NEM Reform Implementation Forum

Integrating Energy Storage Systems
Bidirectional Unit (BDU) implementation
- Stakeholder feedback & responses

31 May 2023

Examples of invalid regulation trapeziums (1)

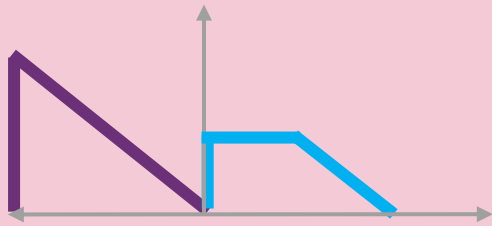
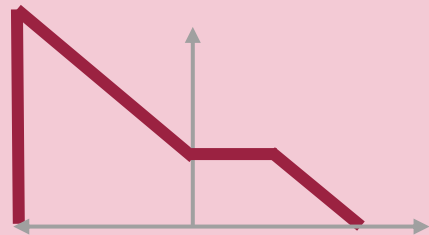
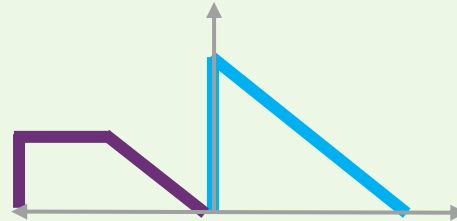
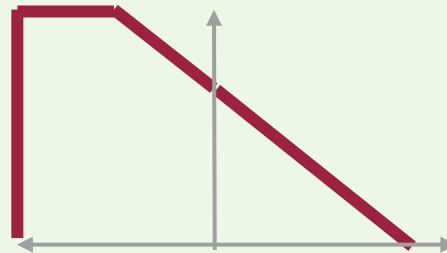
Invalid trapezium

Valid alternative

If the upper angle is less than 90° , both the low and high breakpoint on the generation side must be zero.

Examples of invalid regulation trapeziums (2)

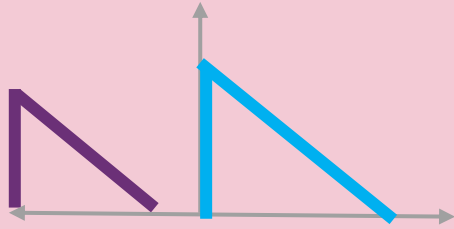
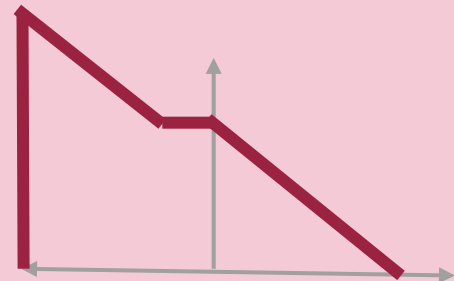
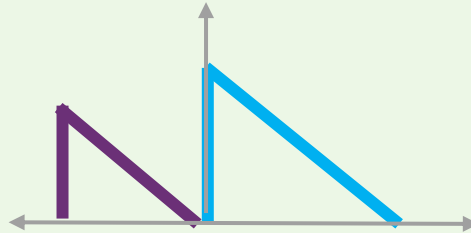
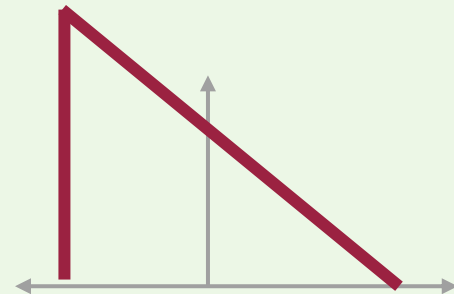
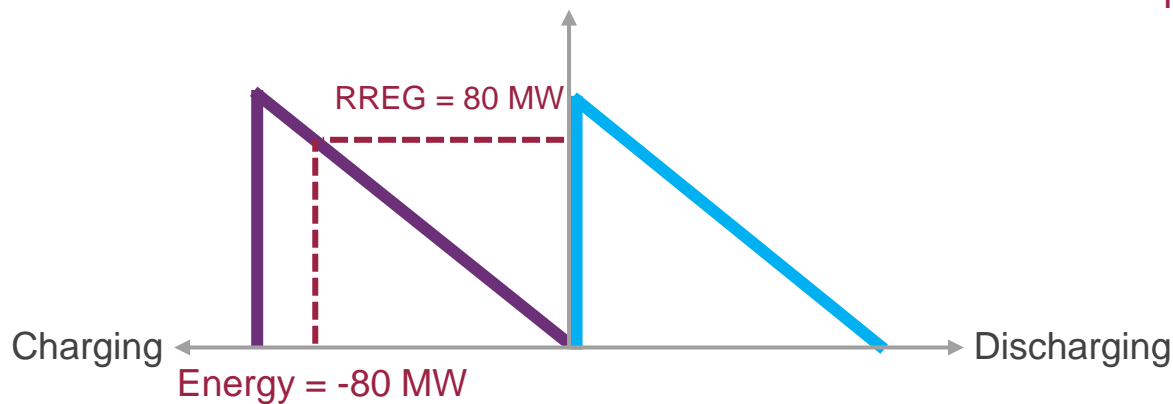
Invalid trapezium ✘

A gap between the trapeziums allows for non-convex solutions.

Valid alternative ✔

Resolved by setting $\text{MaxEnablement}_{\text{Load}} = 0$ (shown) or $\text{MaxAvail}_{\text{Gen}} = 0$

Composite Ramp Rates - Example (1)

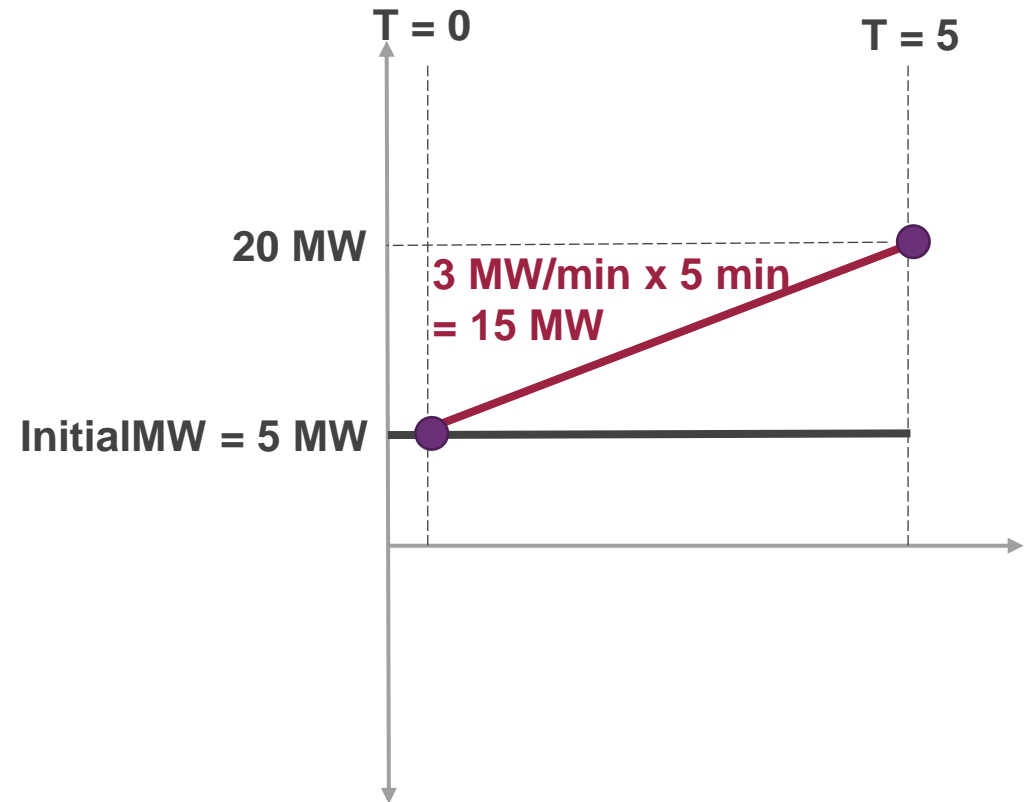
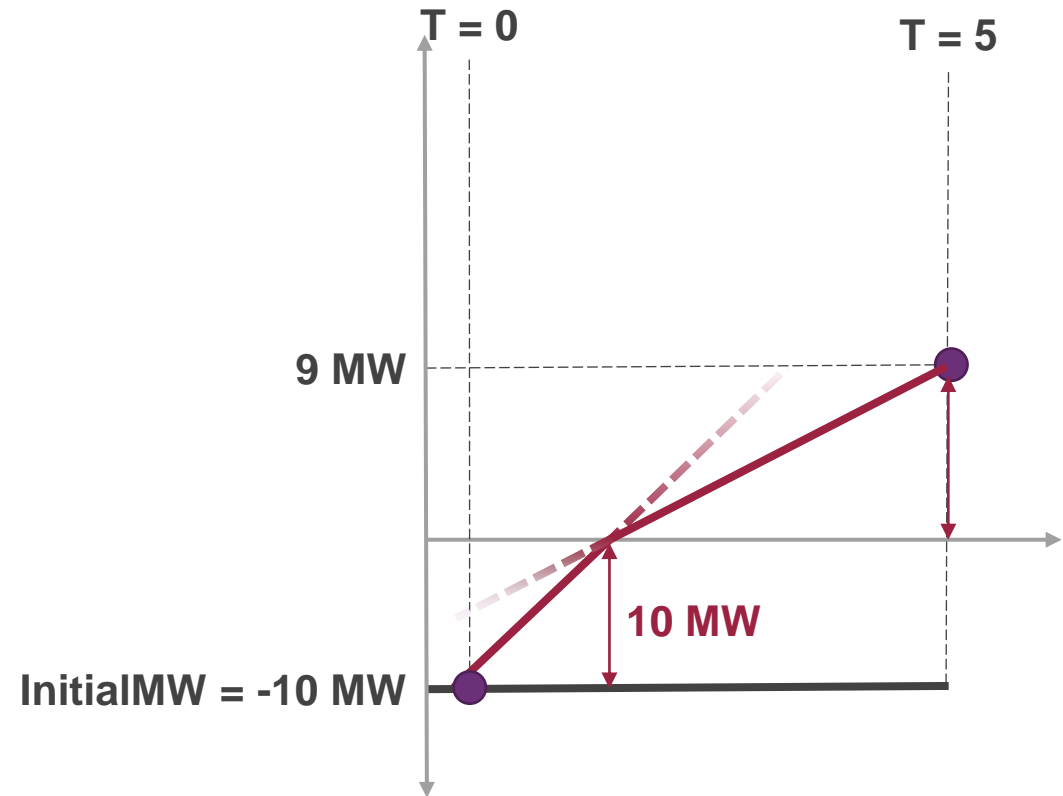
#	Issue	Detail	Response
19	Price Ties	Price tie allocations will be dramatically changed where batteries are offering significantly less than their maximum into a tie situation, creating an unequal playing field.	For price ties, pro-rata tie-breaking (against band availability) would continue to be used, considering: <ul style="list-style-type: none"> • Constraints between BDU load bands, and scheduled load bands • Constraints between BDU generation bands, and scheduled/semi-scheduled units.
20	Ramp Rates	Stakeholders considered that the ramp rate proposal is suitable and flexible though most batteries would be unlikely to require 4 ramp rate limits. Could you please provide one worked example (using the formulas) of the ramp constraint where the charge/discharge transition is not symmetric (+5 MW to -15 MW for example)?	AEMO has included examples below

Stakeholder feedback requested an example of how composite ramp rates work in NEMDE.

For BDUs, separate load/gen-side ramp rates may be specified. Consider ramping in the direction of decreasing load/increasing generation, with ramp-rate limits of:

- **Load side:** 5 MW/min
- **Generation side:** 3 MW/min

If the InitialMW is in the generation side (5 MW), increases to the TargetMW will be limited by the gen-side rate only.

$$\text{TargetMW} \leq 5 \text{ MW} + 3 \text{ MW/min} \times 5 \text{ min} = 20 \text{ MW}$$

Instead consider that the InitialMW is in the load side (-10 MW).

TargetMW will be limited by the load-side rate... but may also be limited by the gen-side rate.

$$\begin{aligned}
 \text{TargetMW} &\leq \text{MIN}(0, 5\text{MW}/\text{min} \times 5\text{min}) \\
 &+ 3\text{MW}/\text{min} \times \text{MAX}(0, 5\text{min} - \text{ABS}(-10 \text{ MW}) / 5\text{MW}/\text{min}) \\
 &= 9 \text{ MW}
 \end{aligned}$$
